FORMAL SITE RE-EVALUATION

OWNER: WIDMARK RICHARD J/FAY M

MAP ID: 35-4W-27

TAX LOT: 1500

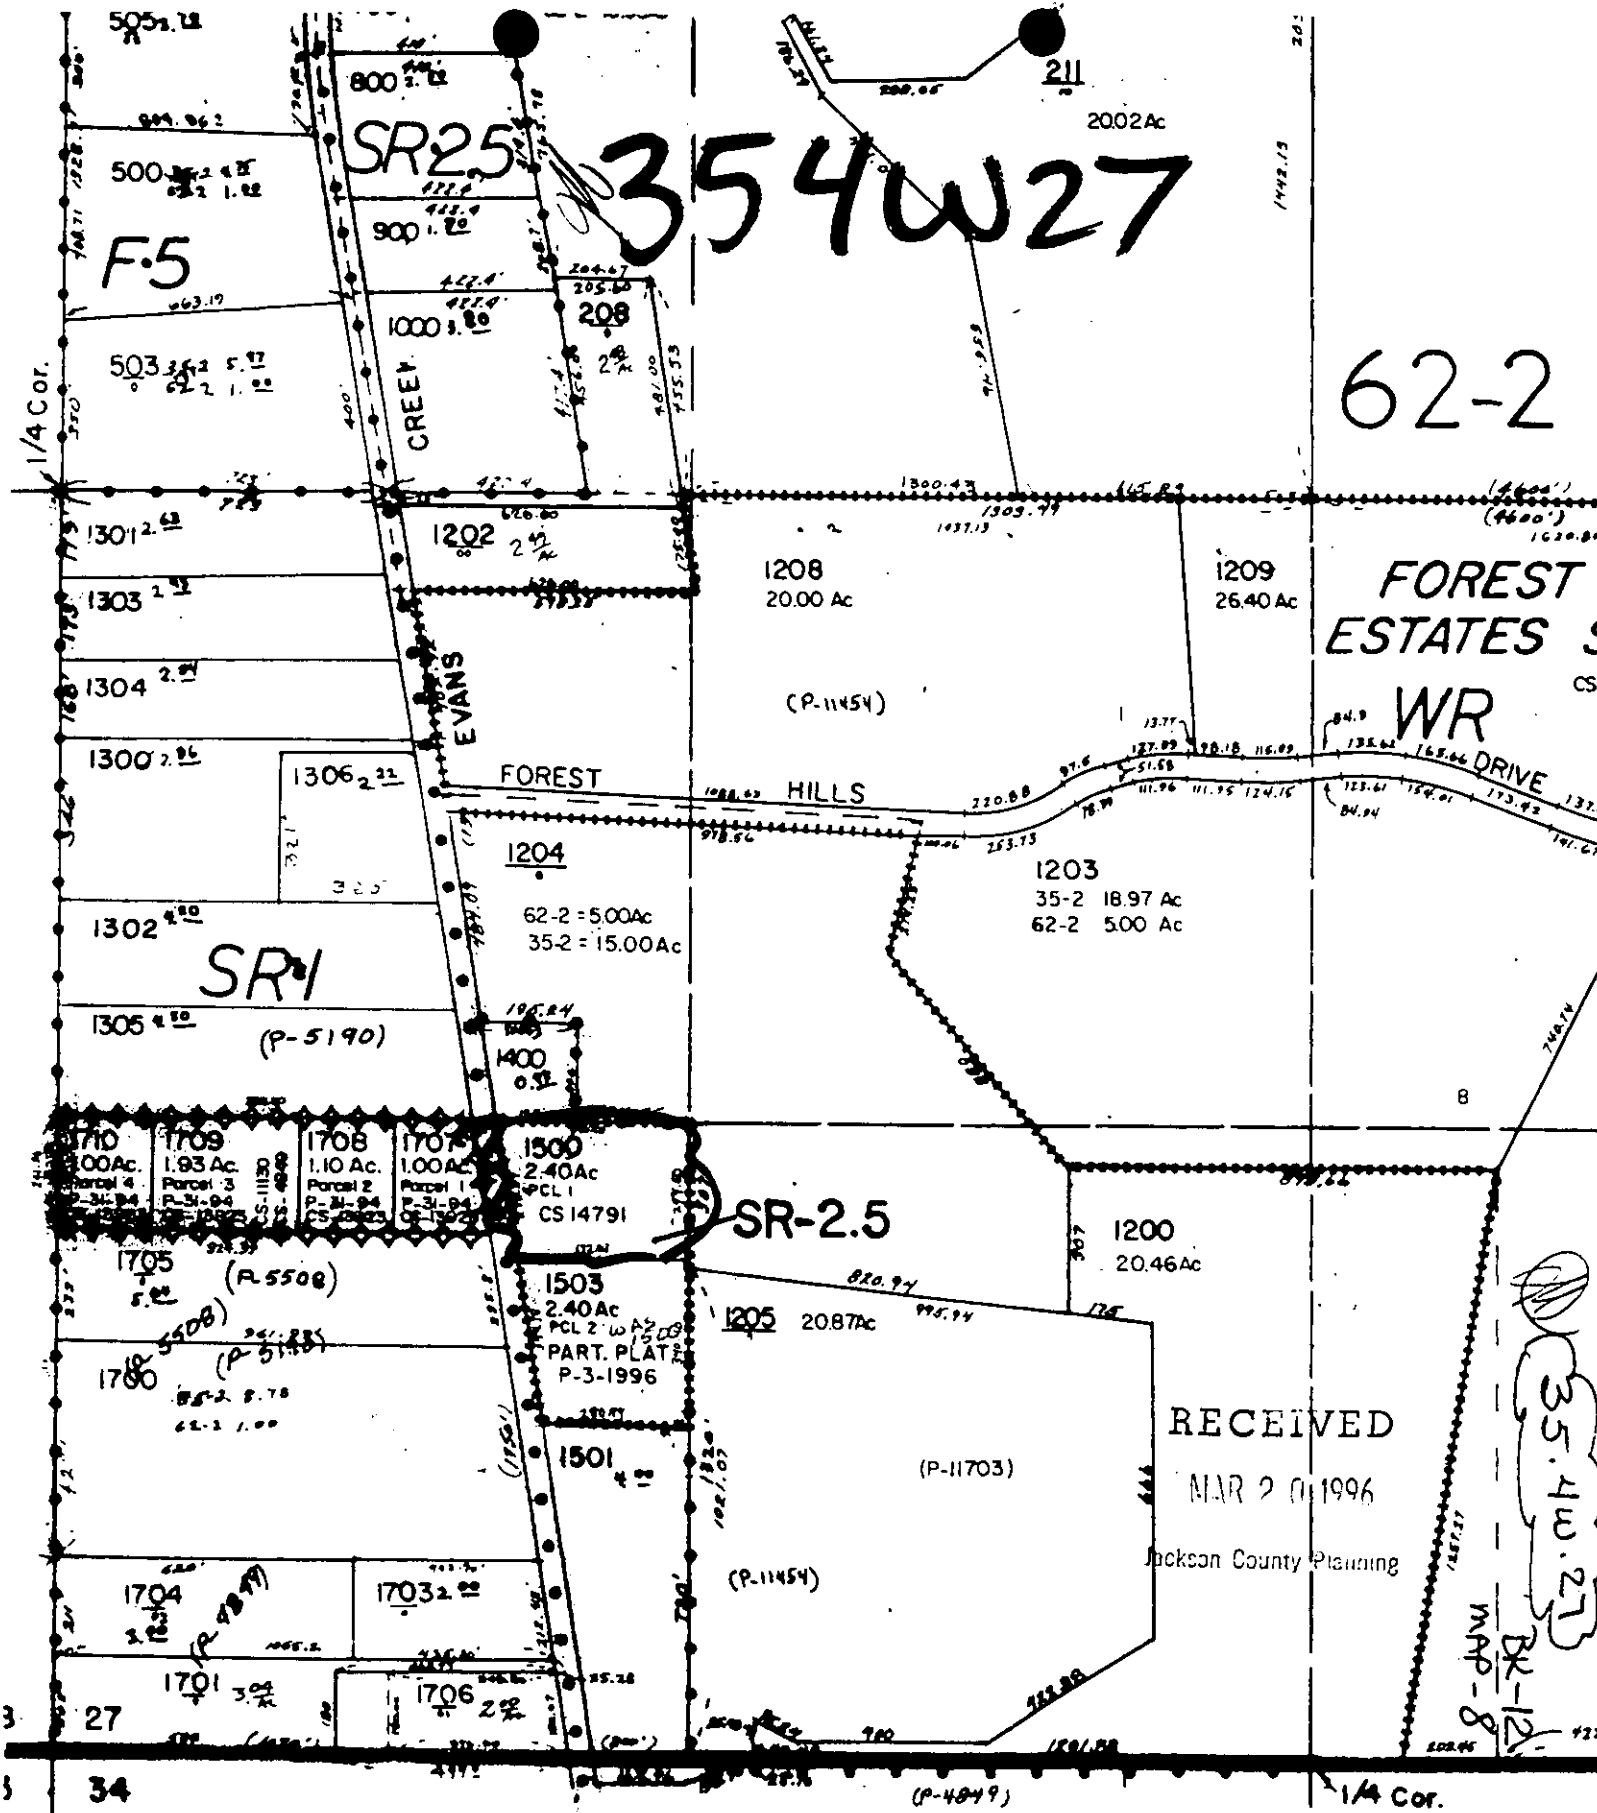
This lot has now been split creating lot numbers 1500 and 1503. In reviewing the septic approval it appears that this site is located partially on 1503. Dick Florey indicated that the fence line listed as P/L is probably the south property line of 1500 with 1503 being the southern tax lot. Before any permits can be issued an recorded easement will be necessary. We will need to verify with the applicant that the property line is as indicated on the approval.

Position: Foot Slope - Side Slope - Top - Fan - Hi Terrace - Lo Terrace - Bottom - Other
Relief: Smooth - Concave - Convex - Undulating - Hummocky May require double pumping depending on cap & filter location

Additional Notes After phone conversation with Mr. Widmark it was discovered he owns both properties. He will Record affidavit in both deeds before permit is issued.

SITE SUITABILITY: Not Suitable. Not enough useable area USEABLE AREA: 90x60 ft
Site Evaluation By: Florey Date On-Site: 4/22/92 Date Completed: 5/6/92
5/14/92

Suitable for SAND FILTER 5/22/92

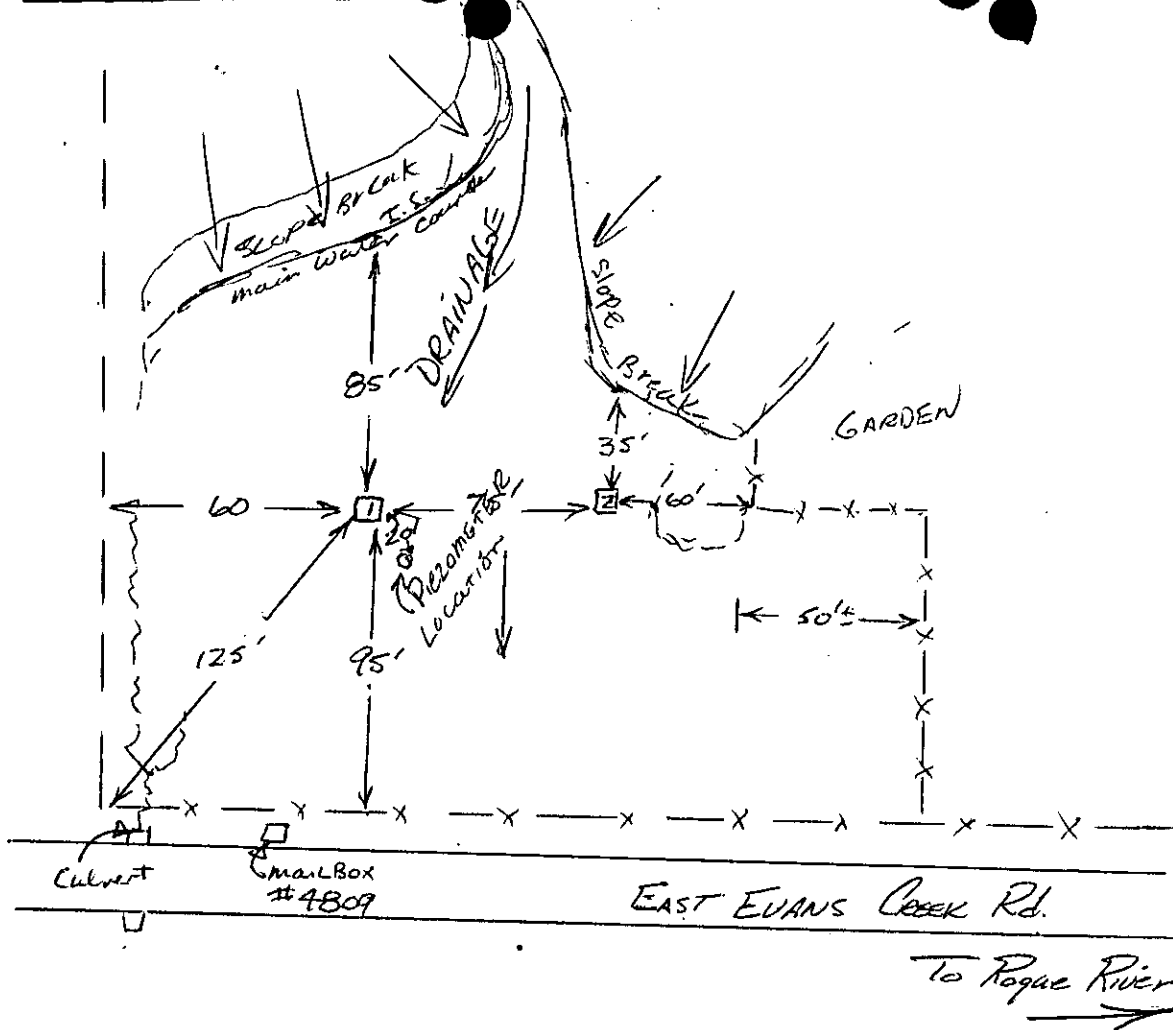
340
71-030
1(c)

76" to Permanent
water table
indicated by modeling

water table at surface
as indicated by modeling

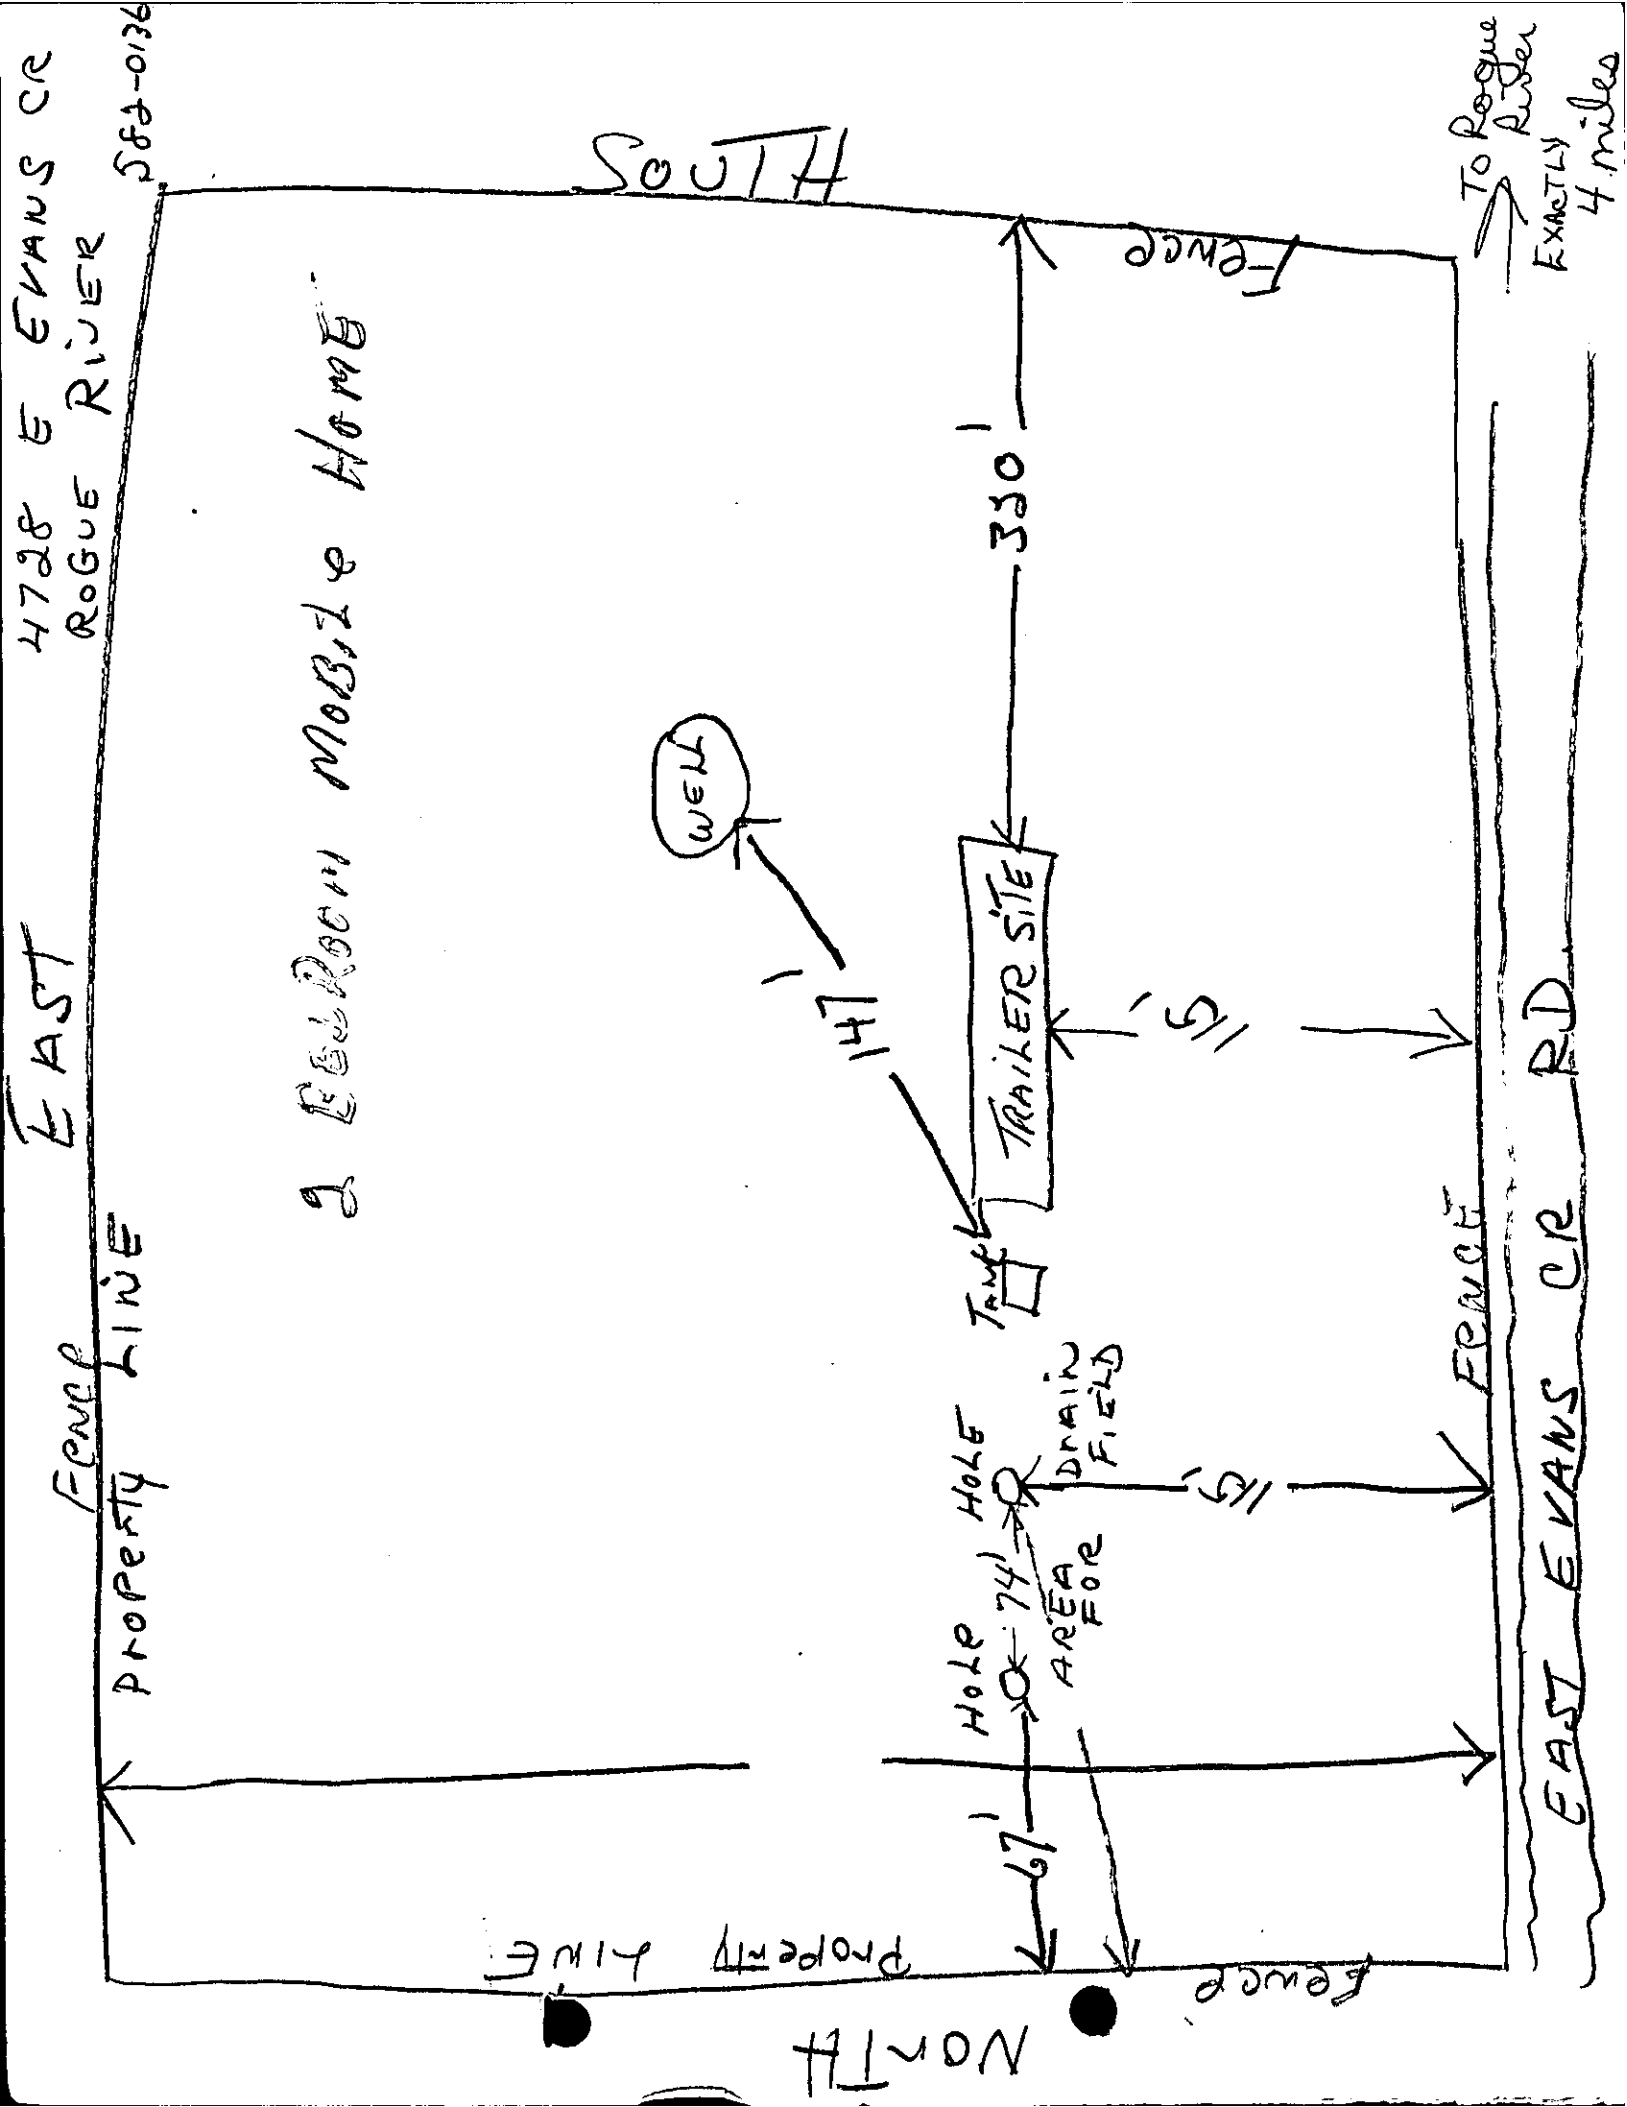
Additional Notes: SITE IS Located in a drainage w/about 3% slope.
I cannot see anyway to drain site - Possibly Permanent water table
PITS STILL Moist in Bottom

SITE SUITABILITY: NOT Suitable for Standard System

USABLE AREA: too shallow to Permanent water table
